Mortdale Resource Recovery Facility

*State Significant
Development
Modification Assessment
(SSD 7421 MOD 1)*

May 2019

Figure 5 | Location of Stacking Spaces

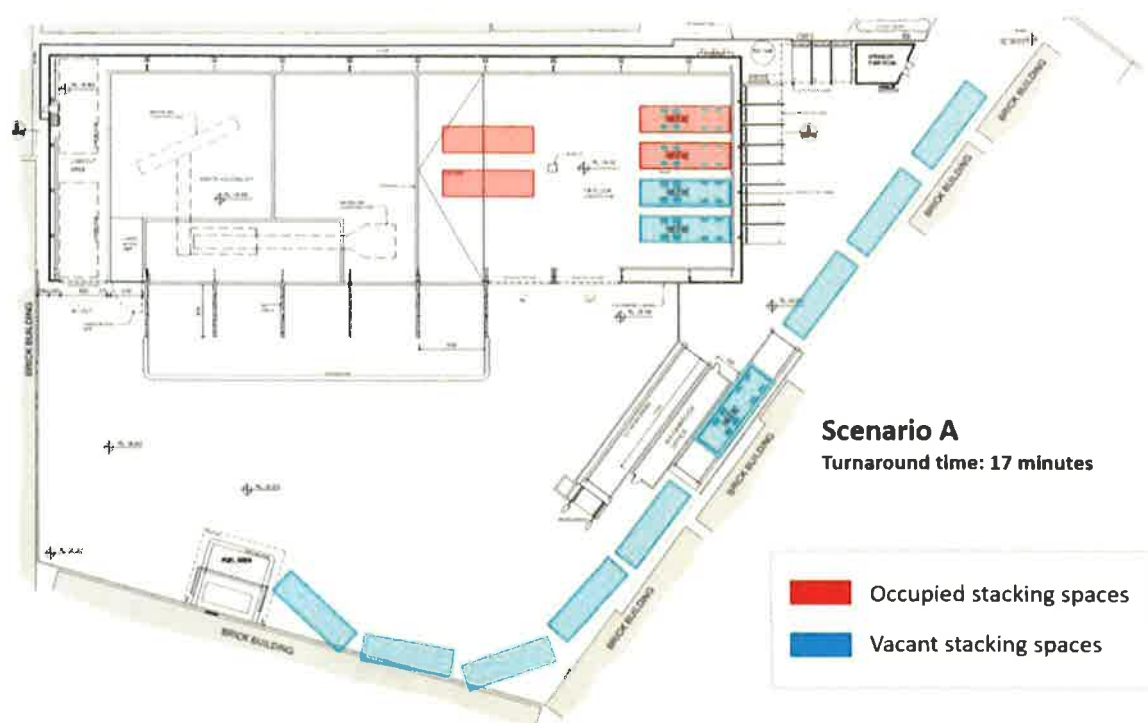
Stacking spaces provide waiting areas for trucks within the site. The modified site layout reduces the total number of stacking spaces from 28 to 15 spaces. The 15 spaces include nine spaces along the boundary of the site and six spaces within the waste processing building (see **Figure 5**). This reduces the number of spaces available for waiting trucks and increases the potential for trucks to queue in Hearne Street awaiting access to the site.

The Applicant justified the reduction in stacking spaces based on other changes to on-site traffic movements including the number of trucks accessing the site during periods of peak operations and reduced time each truck spends on-site.

Under typical operations, based on a turnaround time of 17 minutes on-site, the stacking assessment calculated that each stacking space could therefore accommodate 3.5 trucks an hour ($60 \text{ minute} / 17 \text{ minutes}$). The proposed stacking arrangement could accommodate 52 trucks an hour ($3.5 \text{ trucks} \times 15 \text{ spaces}$). During periods of peak operation (6am – 7am and 12pm – 2pm) 18 trucks are expected to arrive each hour and these could be accommodated in six stacking spaces leaving nine spaces vacant. Under a worst-case scenario of a truck being on-site for 30 minutes, each stacking space could accommodate 2 trucks an hour ($60 \text{ minute} / 30 \text{ minutes}$). This is equivalent to 30 trucks an hour across the site ($2 \text{ trucks} \times 15 \text{ spaces}$). Which is considered adequate to accommodate the trucks per hour during peak operations.

Council raised concerns regarding the potential for trucks to queue on Hearne Street, however accepted that the impact could be mitigated through the existing condition which prohibits queuing in Hearne Street and the Traffic Management Plan (TMP) and Traffic Control Plan (TCP) to be implemented under existing conditions of consent.

The Department has considered all information regarding on-site vehicle movements and the results of modelling which have shown that the site could still accommodate all trucks on the site without causing queuing in the local road network during a worst-case scenario. The Department is also satisfied that through the implementation of the TMP and TCP protocols will be in place alert Bingo's drivers to bring loads of waste to another facility in their network in an unlikely scenario that stacking spaces on-site are full. This would ensure that queuing in Hearne Street is further avoided.
